Reviewed for code compliance
with IRC 2015
Kitsap County Building Department
ibowling@co.kitsap.wa.us
06/03/2020

TODD MILLS
36'x36'x16' POLE BUILDING
1855 NW VAA ROAD
POULSBO, WA 98370
KITSAP COUNTY

Permit Number: 20-01902

SHEET No. S1

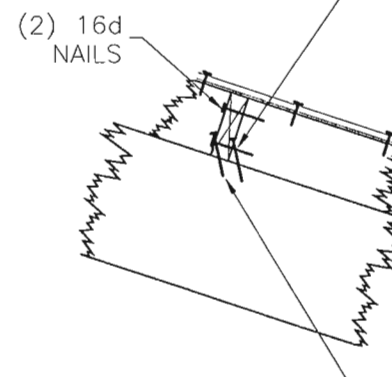
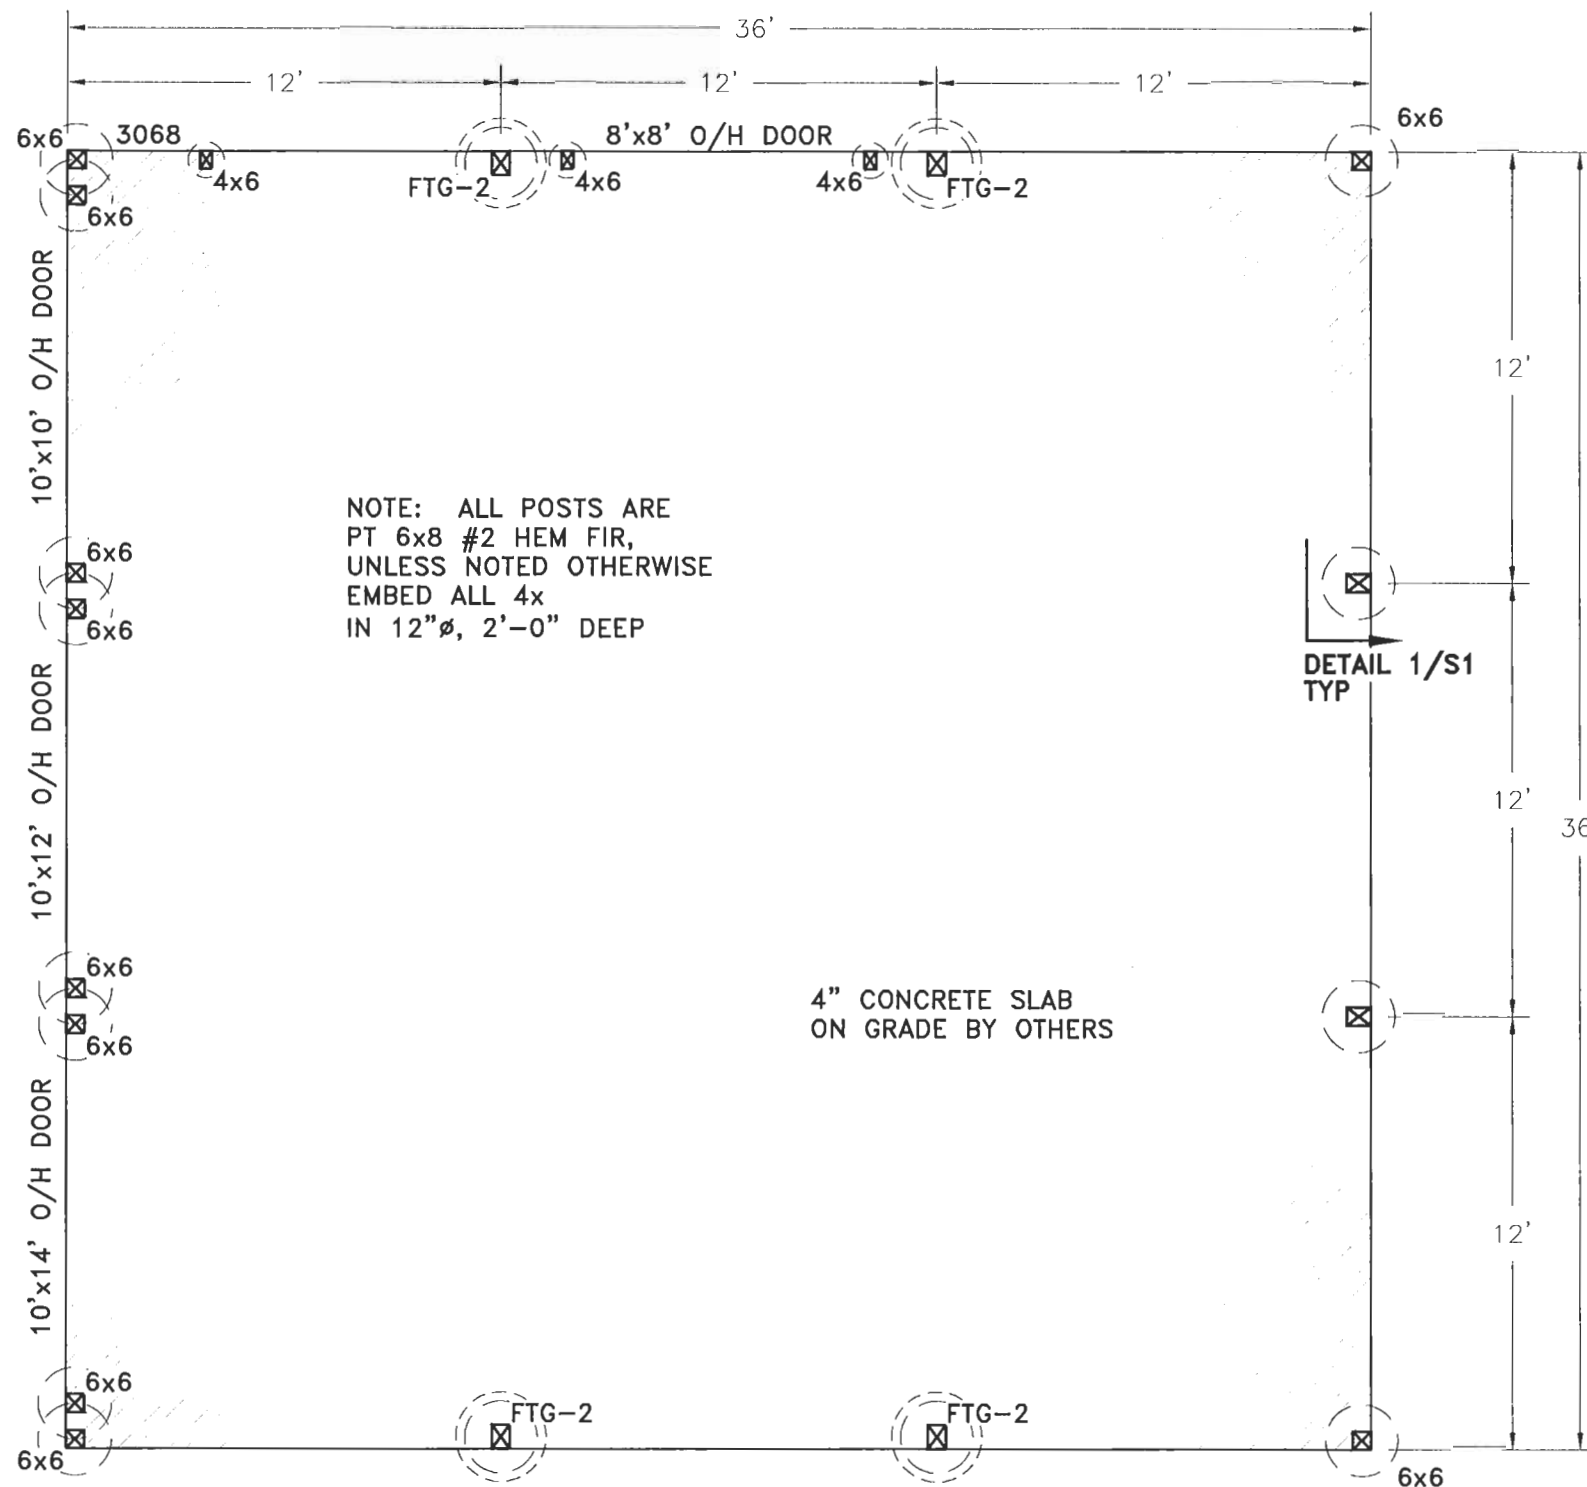
NOTE: CONTRACTOR
SHALL VERIFY THAT 20d
TOENAIL DOES NOT EXIT
SUPPORT FRAMING

Corrosion Resistant Fasteners:
Fasteners for pressure preservative and fire-
retardant treated wood shall be of hot-dipped
galvanized steel, stainless steel, silicon bronze or copper.
Exception: Half inch diameter or greater steel bolts

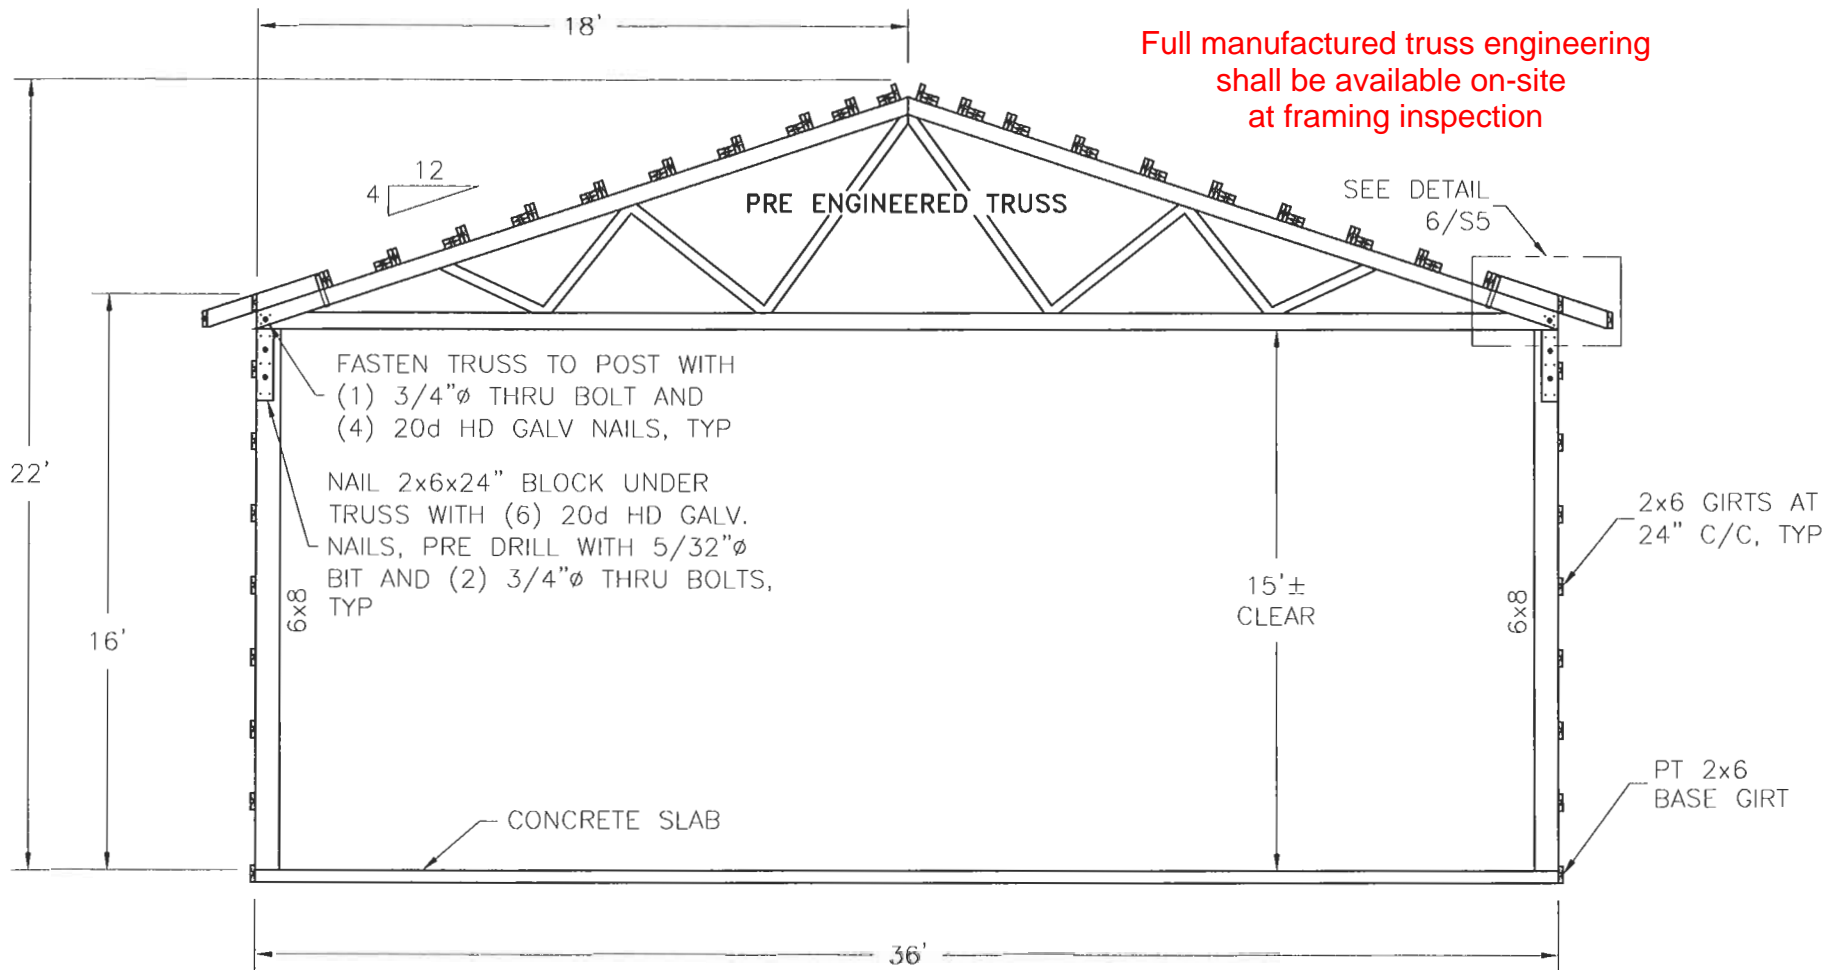
Full manufactured truss engineering shall be available on-site at framing inspection

SECTION A - MAIN BUILDING SECTION

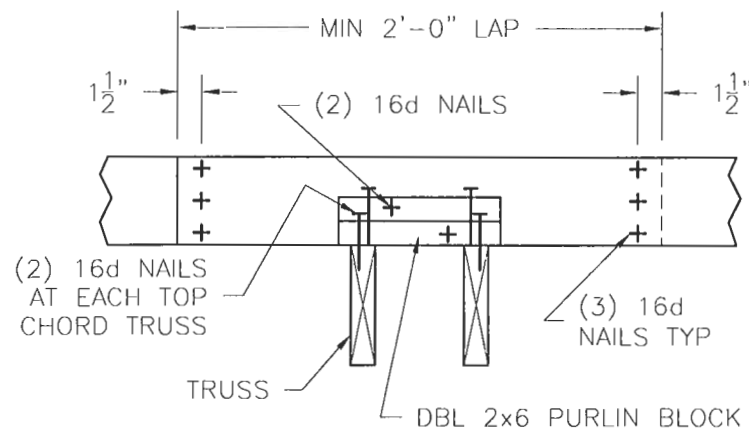
Full manufactured truss engineering shall be available on-site at framing inspection

BUILDING
ELEVATIONS

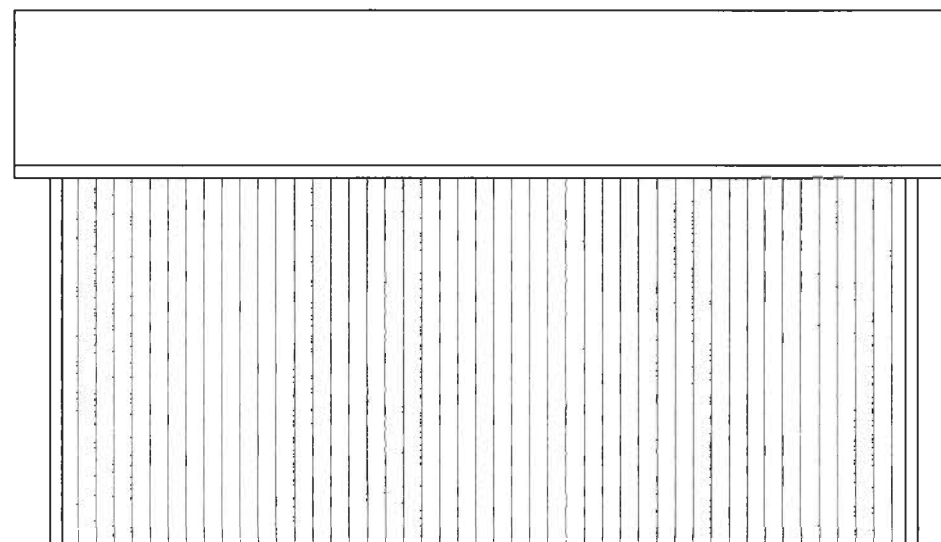
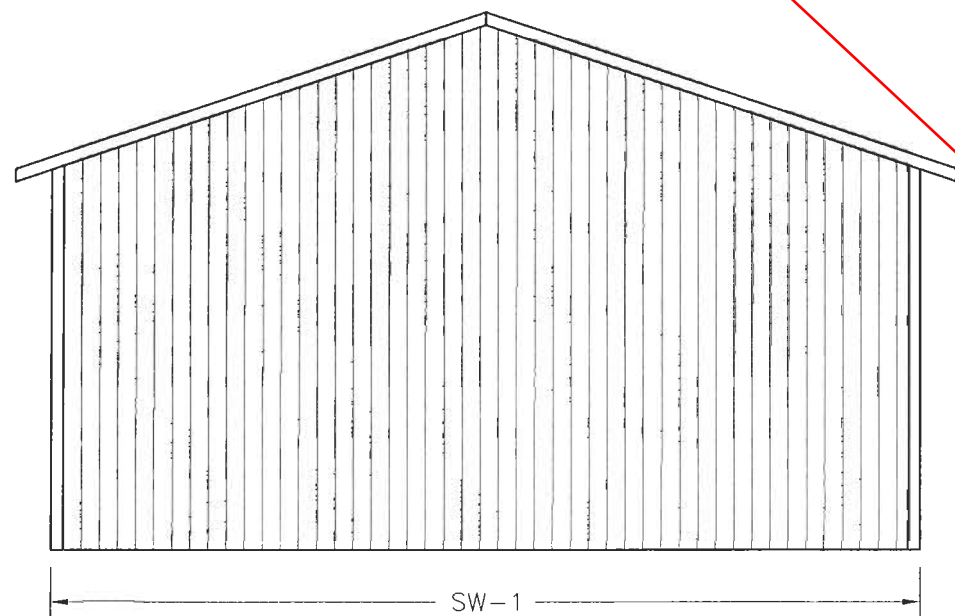
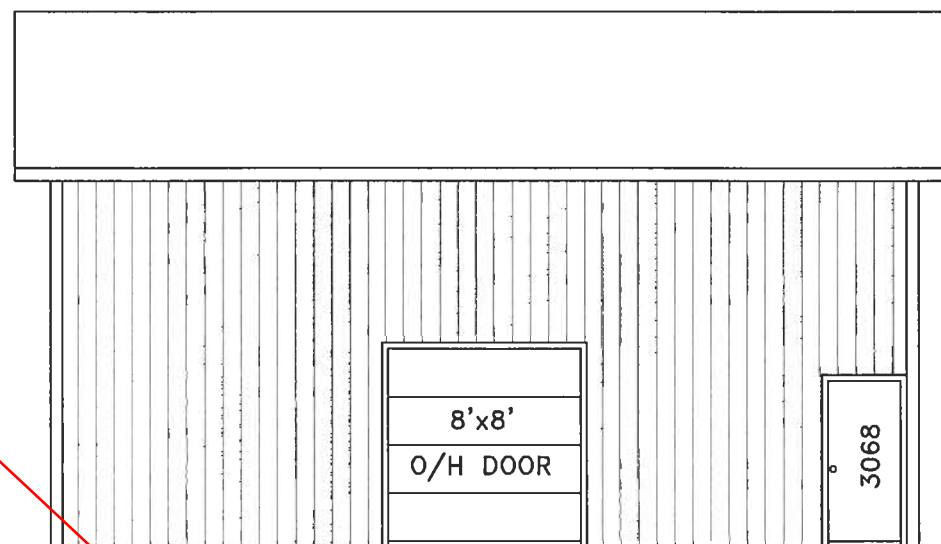
Gutters and downspouts are required.
All roof and yard drains shall be directed to splash blocks at a minimum,
or to an infiltration system if required. All surface drainage shall have a
minimum 2% grade away from the foundation.

see note 8 on Sheet
S1
